re: Geotechnical Review - McKinnon's Creek Alterations
Proposed residential Development
Summerside West - Tenth Line Road - Ottawa

to: David Schaeffer Engineering Limited - Ms. Jennifer Ailey - jailey@dsel.ca
to: David Schaeffer Engineering Limited - Mr. Steve Pichette - spichette@dsel.ca
to: Mattamy Homes - Ms. Jillian Normand - Jillian.Normand@mattamycorp.com
date: October 30, 2018
file: PG4049-MEMO.10 Revision 1

McKINNON'S CREEK
PROPOSED ALTERATIONS
PLAN AND CROSS-SECTIONS

Northern Office and Laboratory
63 Gibson Street
North Bay - Ontario - P1B 8Z4
Tel: (705) 472-5331 Fax: (705) 472-2334

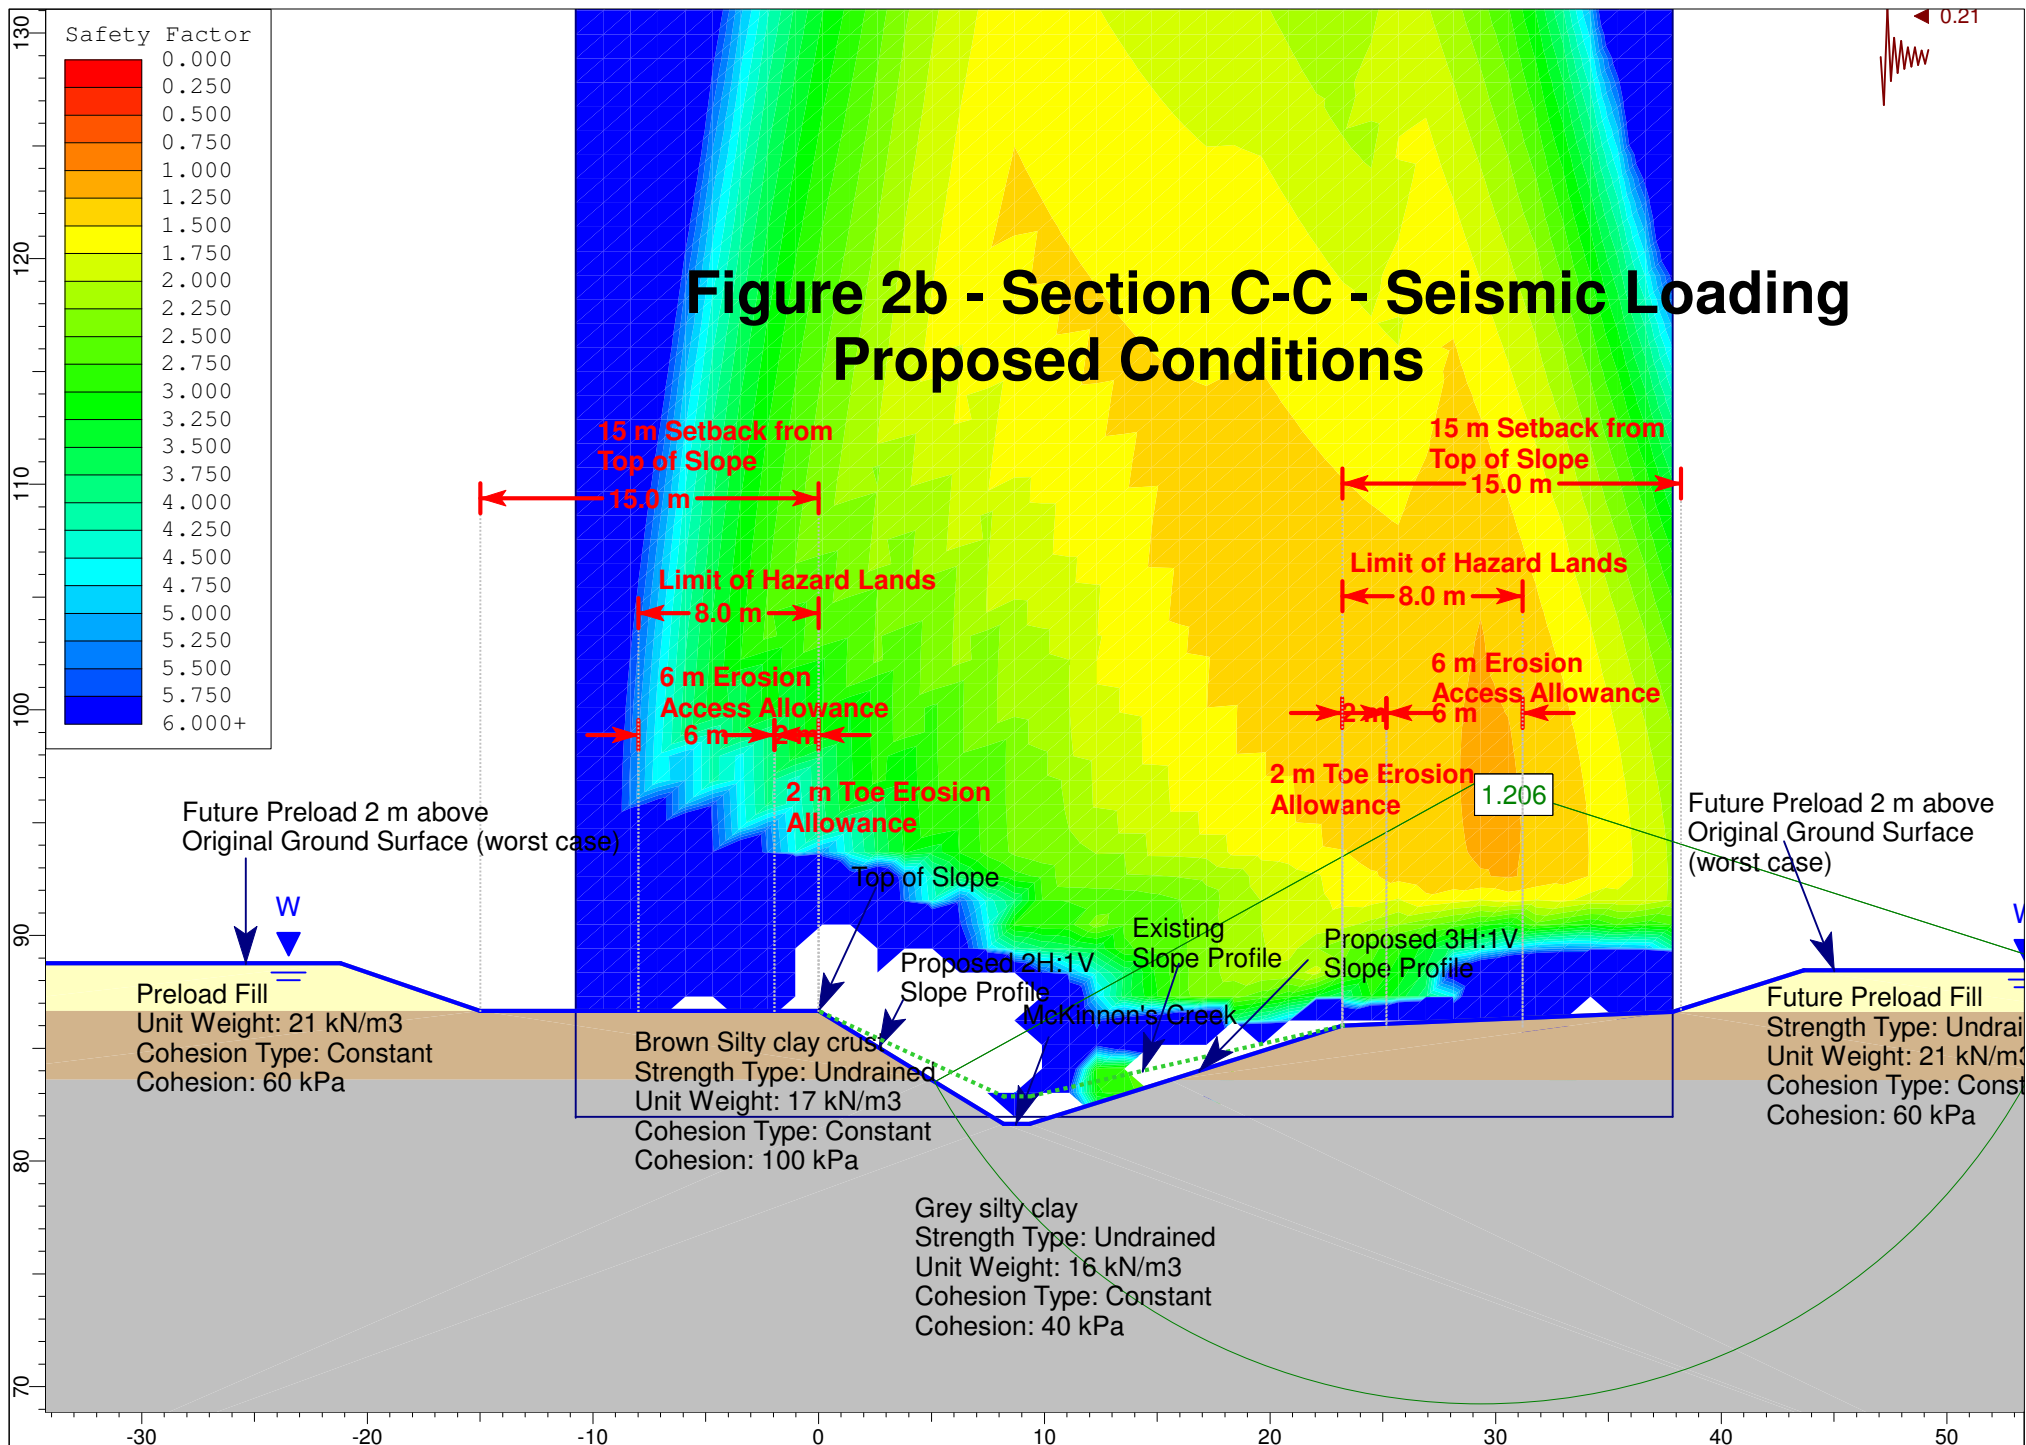
The results of our analysis are presented in Figures 1a, 1b, 2a and 2b attached. Figures 1a and 1b present the results of our global slope stability analysis under static conditions for each side slope of the channel and Figures 2a and 2b present the analysis when considering the seismic loading. Based on our analysis results, Section C-C is considered stable with a global slope stability factor of safety of greater than 1.5 under static conditions and greater than 1.1 under seismic loading. Therefore, a slope stability setback is not required for the limit of hazard lands setback.

SECTION C-C

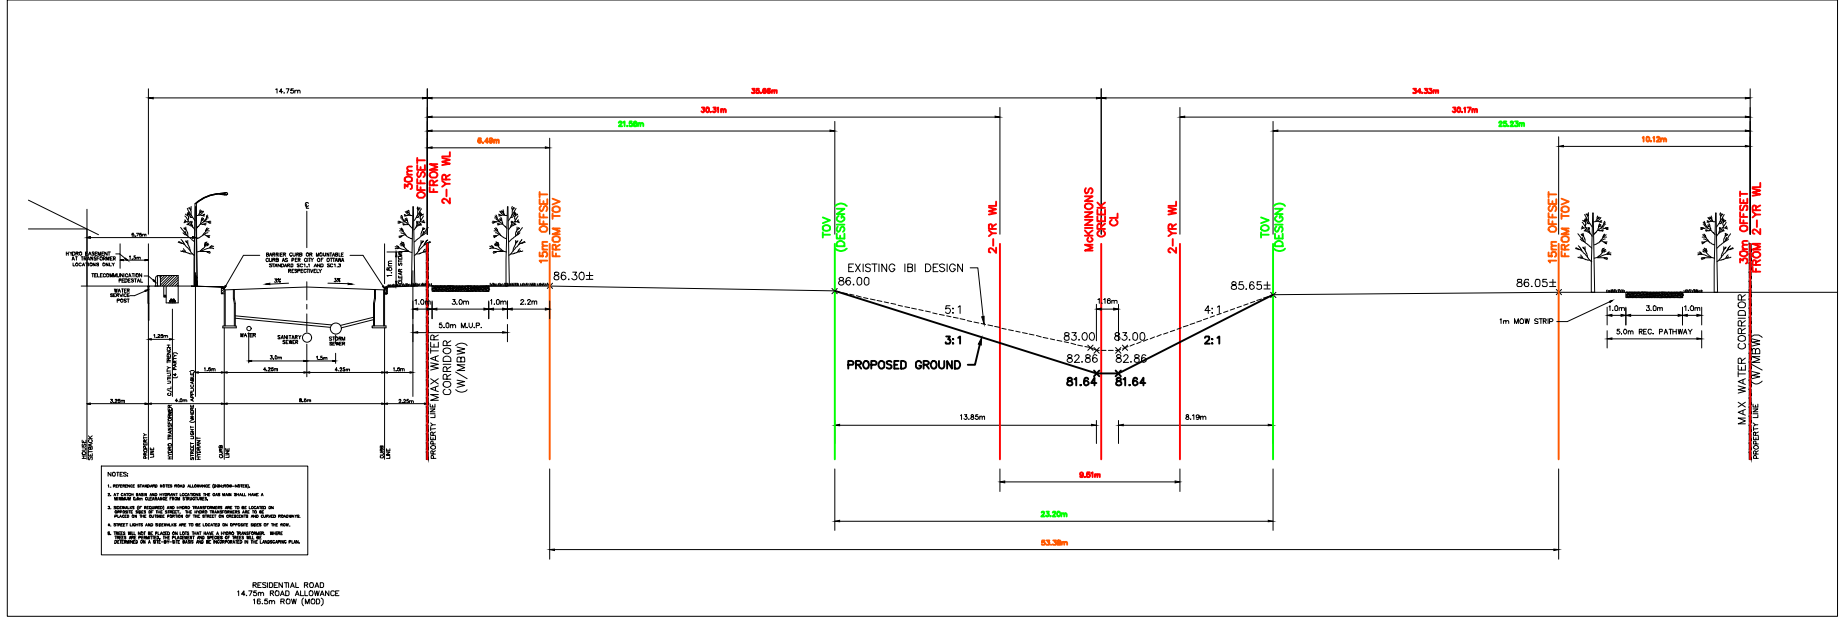
The slope sections presented in the design drawing were reviewed by Paterson. Based on our review, Section C-C was noted to include a 2H:1V slope profile along the east side of the channel and a 3H:1V slope profile along the west side. The remainder of the proposed slope profiles were observed to be greater than 2H:1V. Therefore, Section C-C was analyzed to determine the global slope stability factor of safety as the worst case scenario for the proposed alterations. **The slope stability analysis also considered a 2 m high preload above original ground surface. It should be noted that the assumed 2 m preload fill height is well above the design roadway and pathway grading adjacent to McKinnon's Creek along the west side and is approximately 0.5 m above anticipated lot grading for the lots adjacent to McKinnon's Creek along the east side of the alignment. It should also be noted that no preloading will be completed beyond the geotechnical limit of hazard lands. Also, it should be noted that a settlement surcharge program is not required for the lots, pathways or roadways adjacent to the subject alignment of McKinnon's Creek.**
